PARKER AND PINE FILING NO. 1 LOT 2 – SITE PLAN

MURPHY OIL USA, INC.

SITE PLAN DOCUMENTS

COVER SHEET
MURPHY EXPRESS
12405 SOUTH PARKER ROAD
PARKER
COLORADO

SHEET NO. A1.3

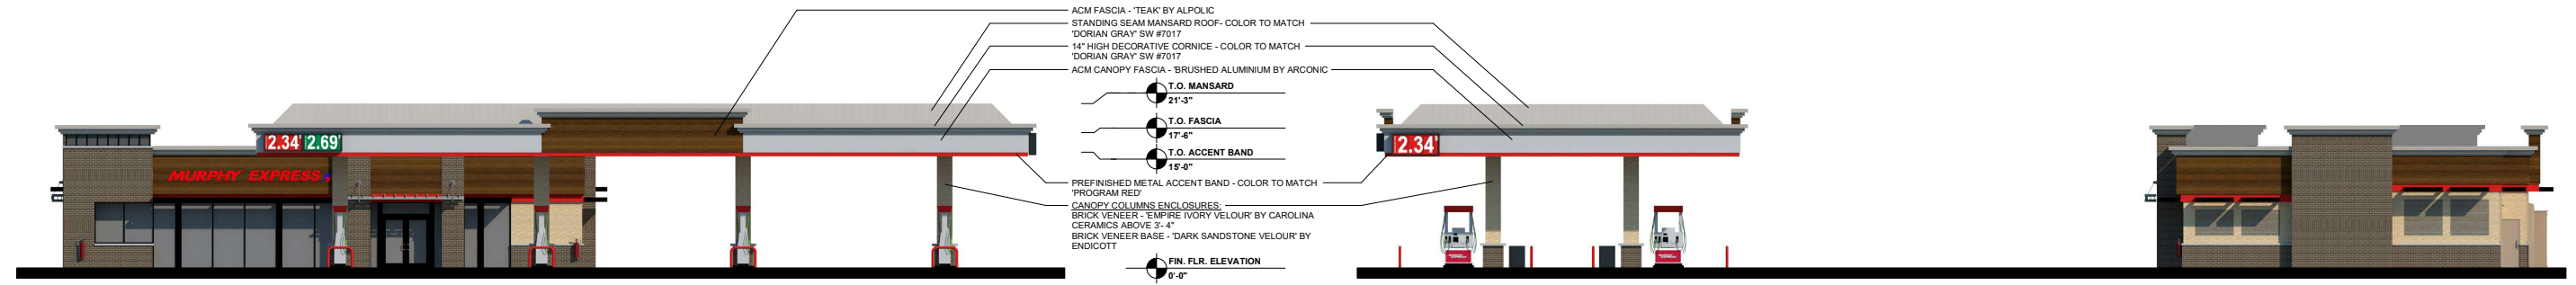
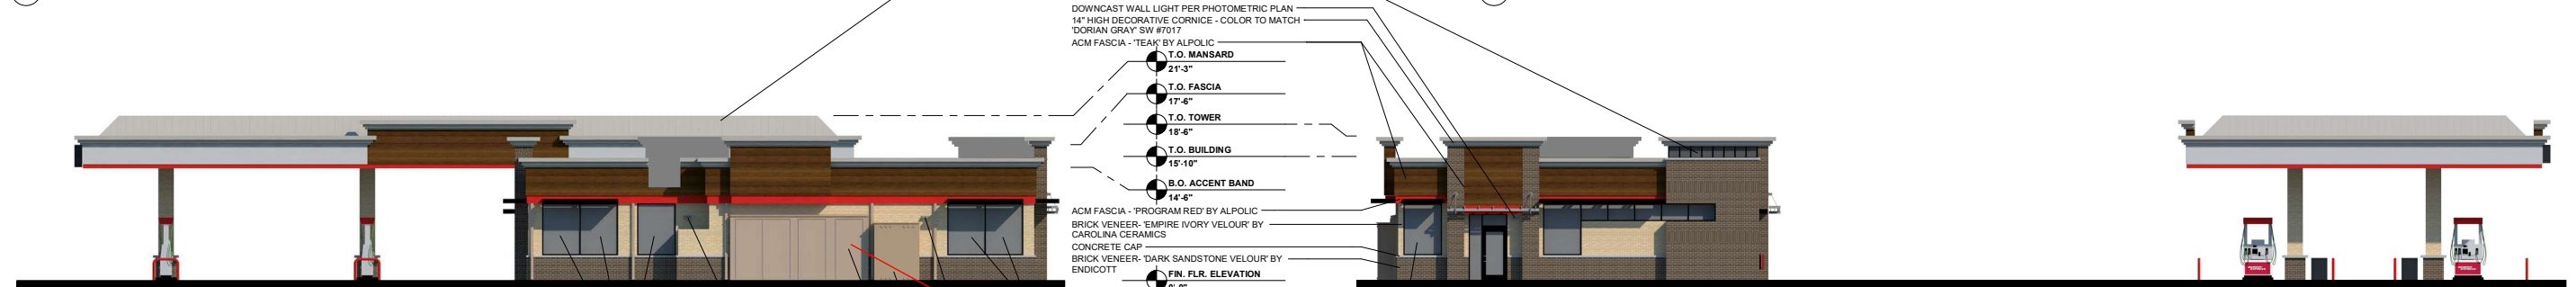
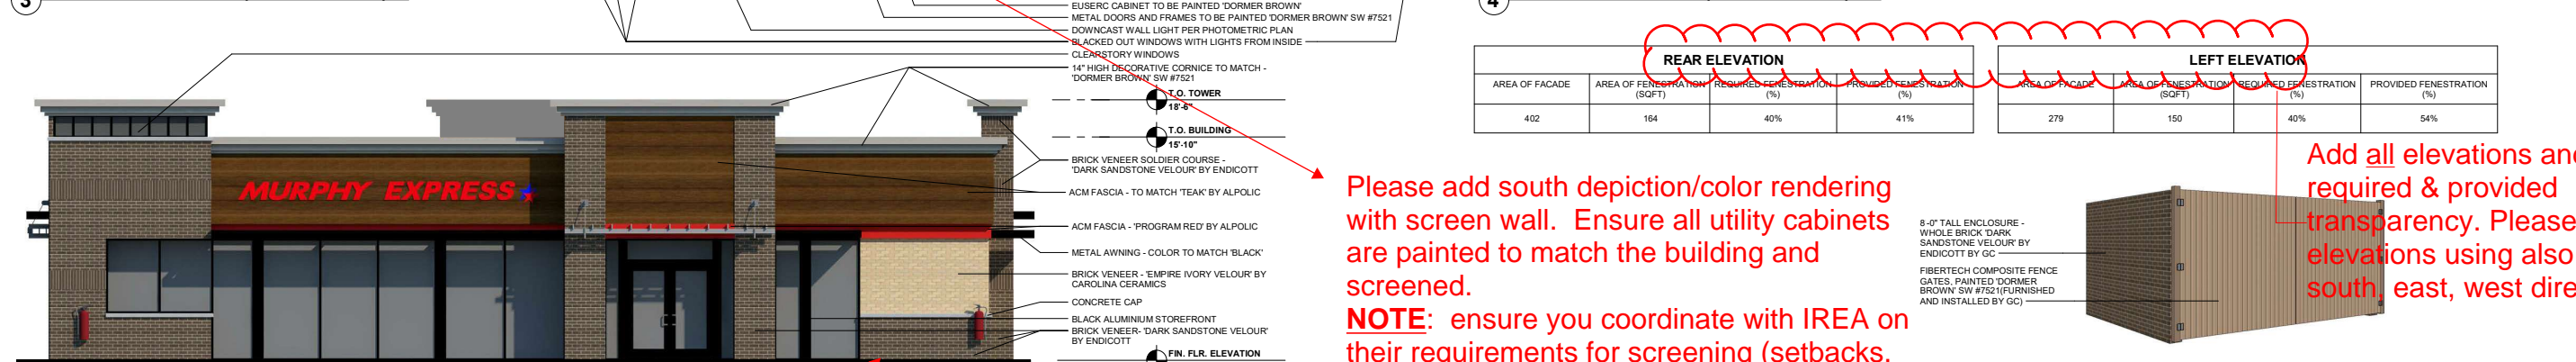
Please add south depiction/color rendering with screen wall. Ensure all utility cabinets are painted to match the building and screened.
NOTE: ensure you coordinate with IREA on their requirements for screening (setbacks, etc.).

Add all elevations and their required & provided transparency. Please distinguish elevations using also north, south, east, west directionals.

Add/show bike racks at front/primary entrance.
